Memorial Park proposed wharepaku: concept and form

Wharepaku building - design detail

Memorial Park proposed wharepaku: suggested material and treatment

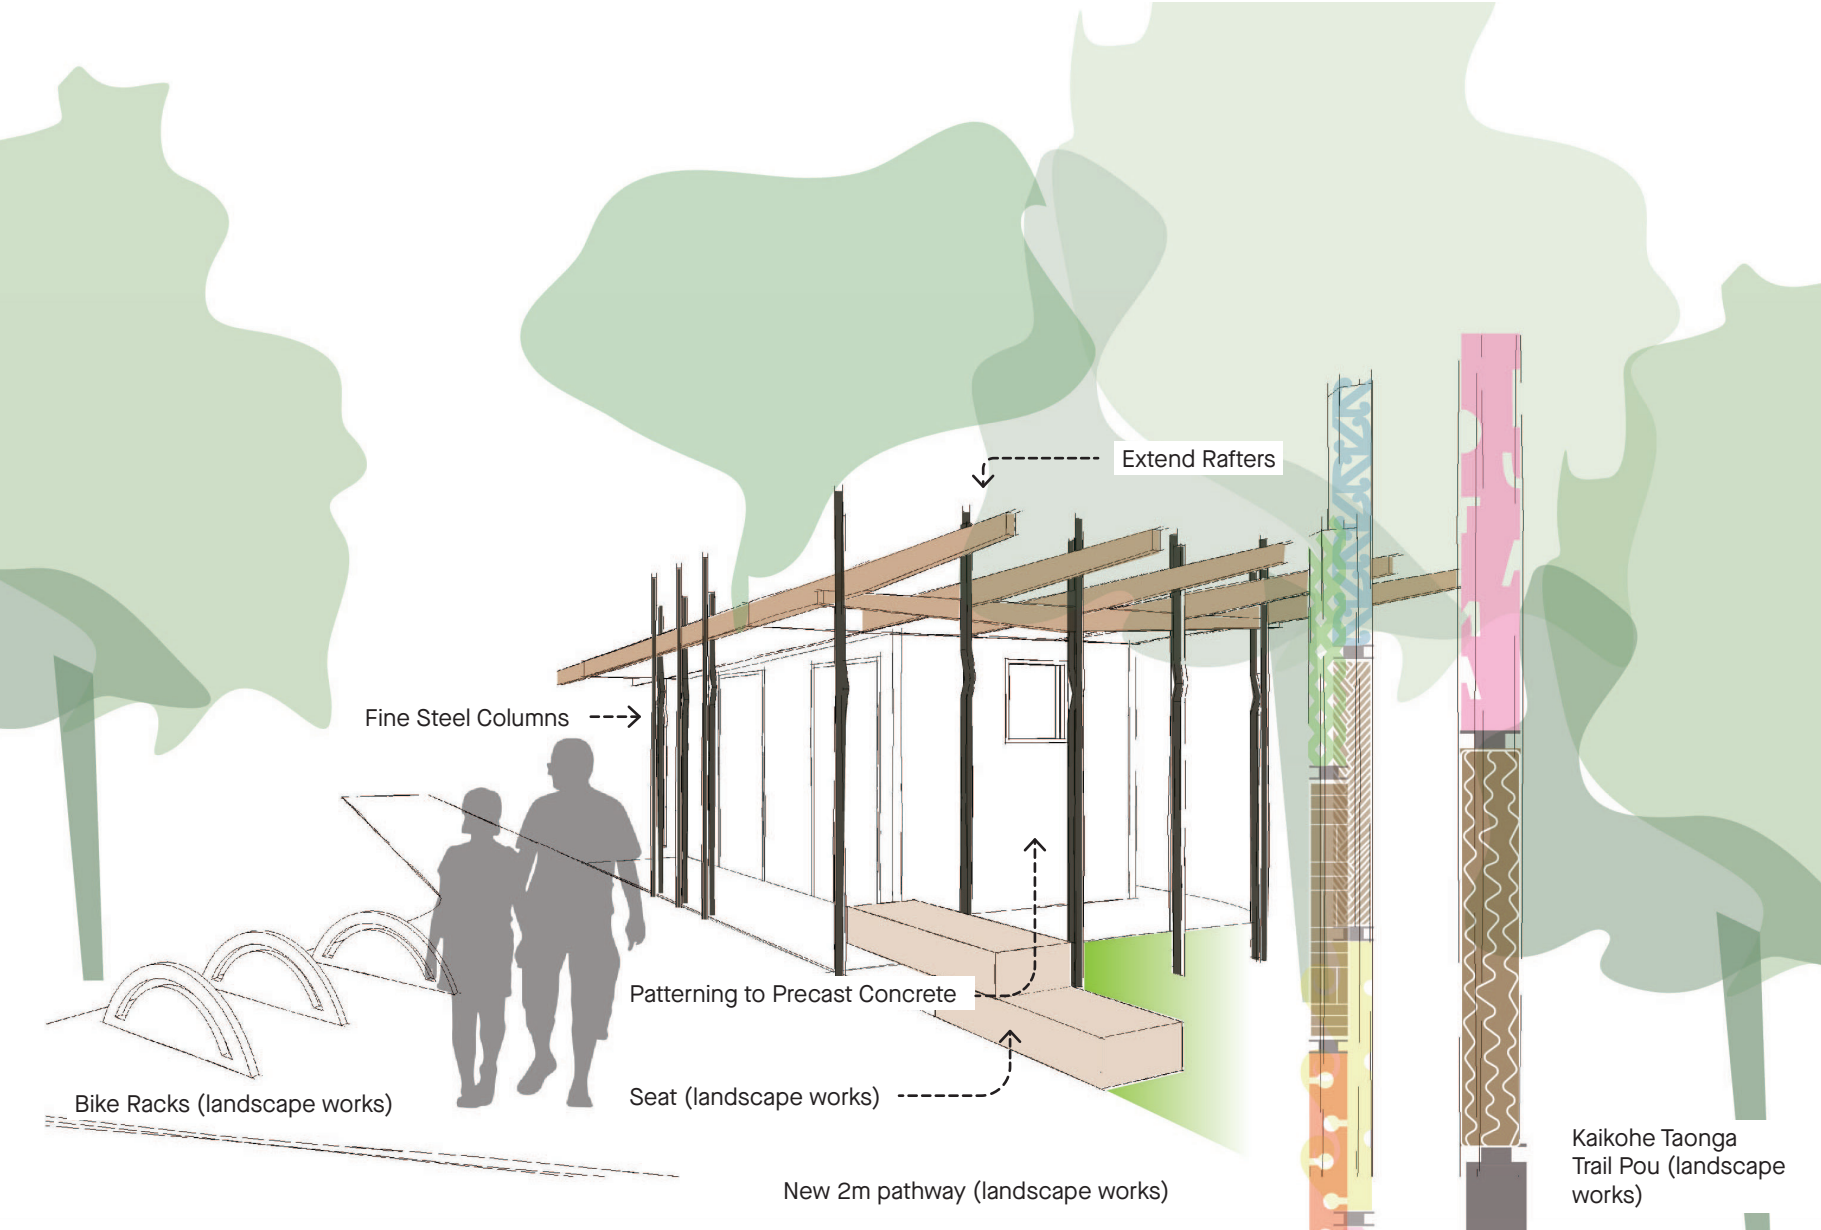
ĀKAU proposes enhancing the visual impact of the wharepaku building through the following modifications:

- Extend rafters, primarily toward Station Road
- Add columns for privacy screening and interest
- Remove ShadowClad to walls and add patterning to exterior concrete walls
- Seating

We believe these simple moves will create a welcoming entry to the park and offer shelter for pedestrians and cyclists.

Location plan

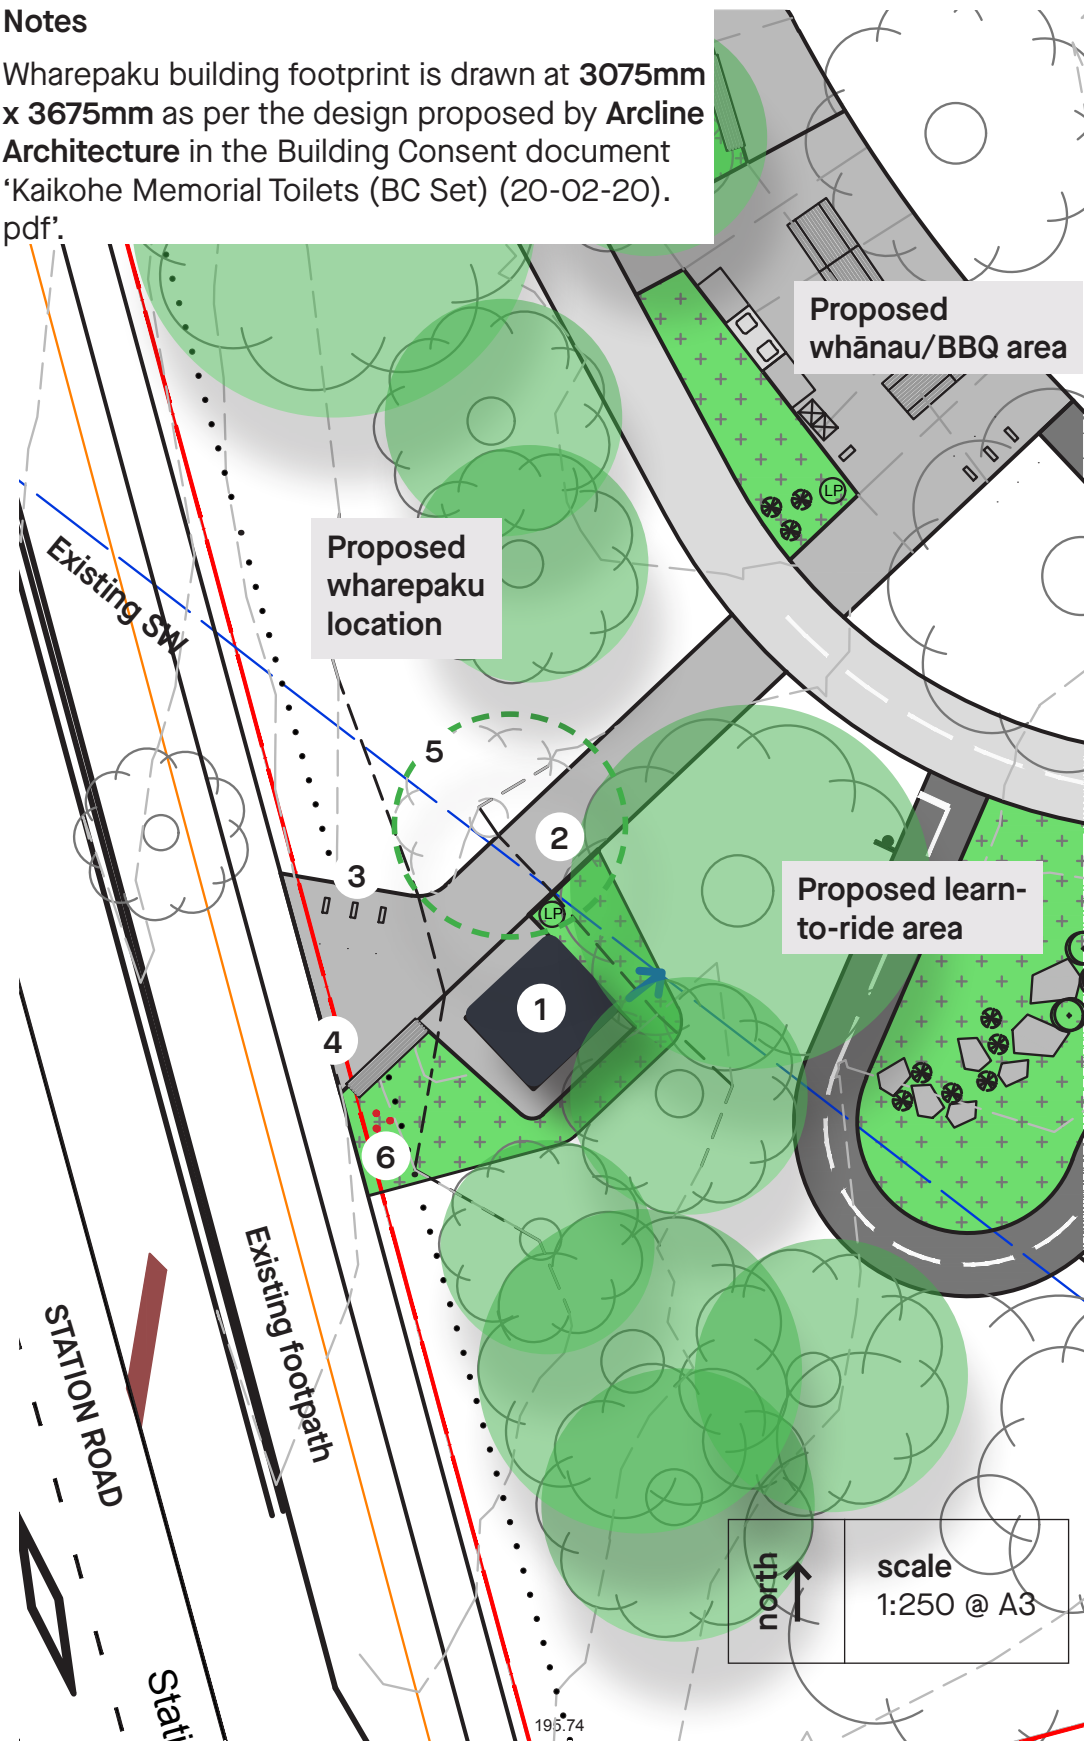
1. Wharepaku building near Station Road
2. 2m wide concrete entrance path
3. 4 no. bike racks
4. Navigation signage
5. Tree to be removed
6. Taonga Trail Pou as markers to park entry - refer below

Wharepaku building footprint is drawn at 3075mm x 3675mm as per the design proposed by Arcline Architecture in the Building Consent document 'Kaikohe Memorial Toilets (BC Set) (20-02-20). pdf'.

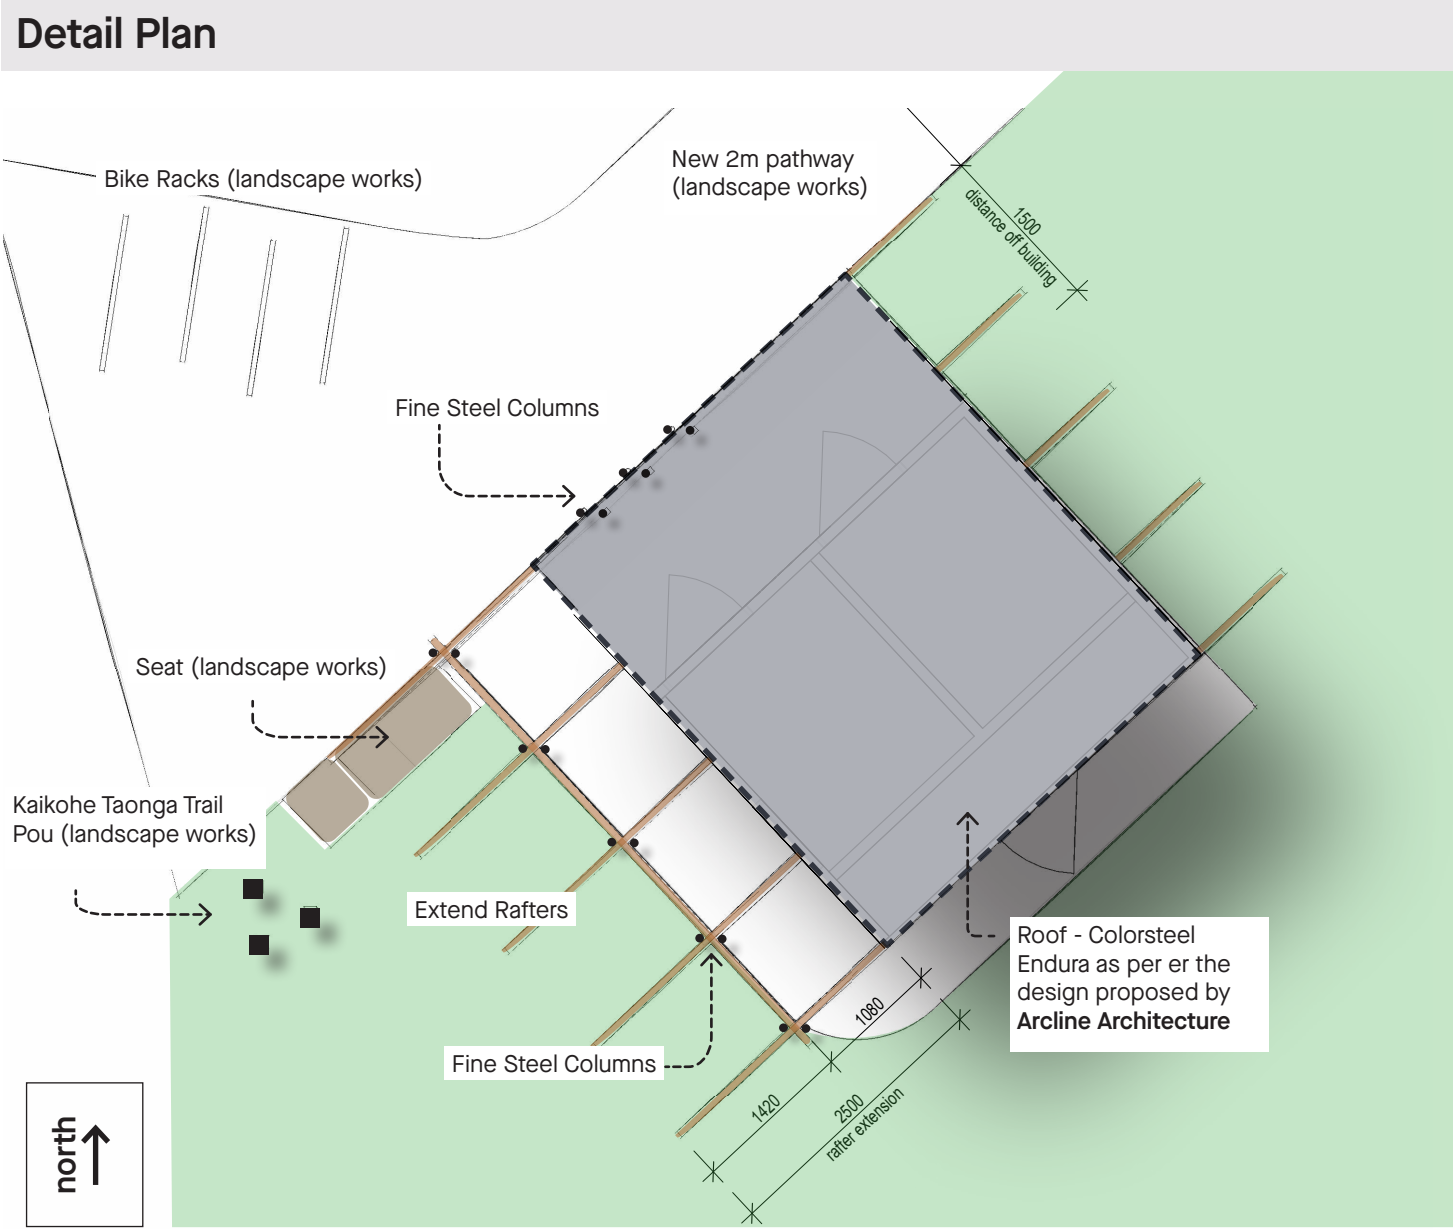
We propose columns are added to the extended roof structure to provide privacy and interest. Sketch shows slight bend/kink in columns to add visual interest. These are detailed as 50mm Circular Hollow Sections.

Consider use of lighting on canopy structure to create a safe and welcoming space around wharepaku.

Coloured pattern and formwork to the precast concrete walls will help to make the wharepaku a positive and visually appealing addition to Memorial Park. We suggest the removal of the proposed ShadowClad and the addition of some patterning to exterior precast walls.

Indicative patterning based on the Kaikohe Taonga Trail Pou. Potential methodology: pattern to be pressed 20mm into precast, and pressed section to be painted. Please assume this will be to 60% of all four facades. Design TBC.
